GROUP	MODEL
ELE	2025MY EV6 (CVa) <u>and</u> 2026 EV9 (MVa)
NUMBER	DATE
409	December 2025

TECHNICAL SERVICE BULLETIN

SERVICE ACTION: INTEGRATED CHARGE CONTROLLER UNIT REPLACEMENT (SA639)

Repair Procedure For EV6 (CVa):

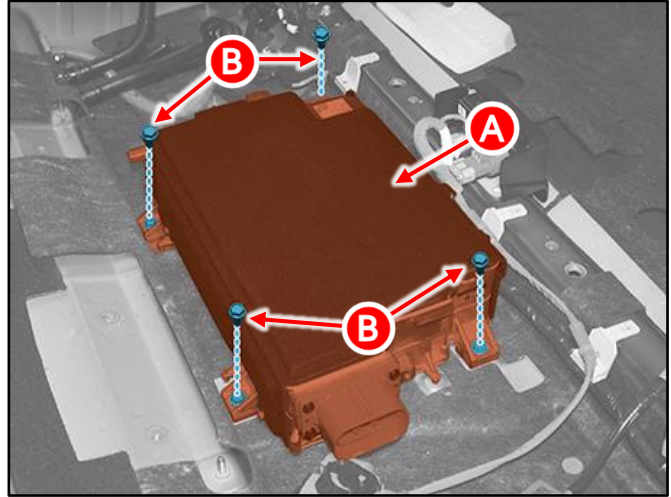
1. Replace the ICCU (A) by referring to "High Voltage Charging System → Integrated Control Unit (ICCU) → Removal and Installation Repair procedures" in the applicable Shop Manual on KGIS.

Tightening torque for ICCU Case to Body Bolts (B): 14.5 - 17.3 lb.ft (19.6 - 23.5 N.m)

Repair Procedure For EV9 (MVa):

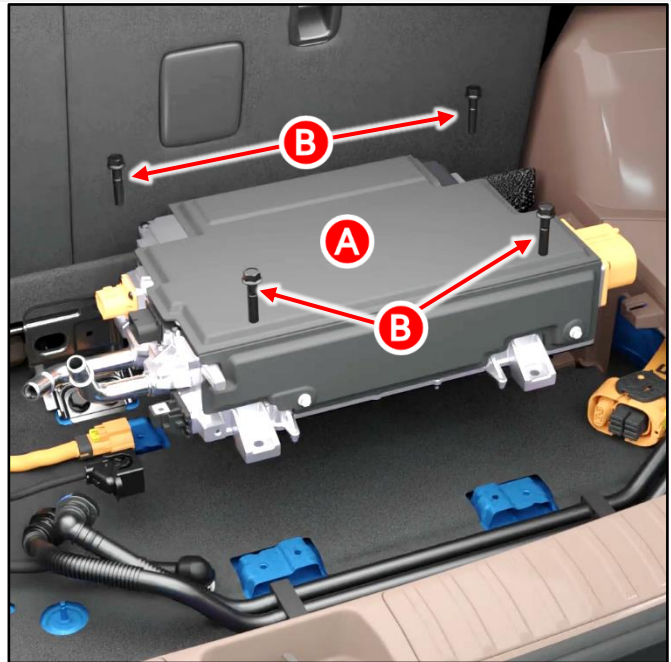
- Replace the ICCU (A) by referring to "High Voltage Charging System → Integrated Control Unit (ICCU) → Removal and Installation" in the applicable Shop Manual on KGIS.

Tightening torque for ICCU Case to Body (B): 14.5 - 17.3 lb.ft (19.6 - 23.5 N.m)
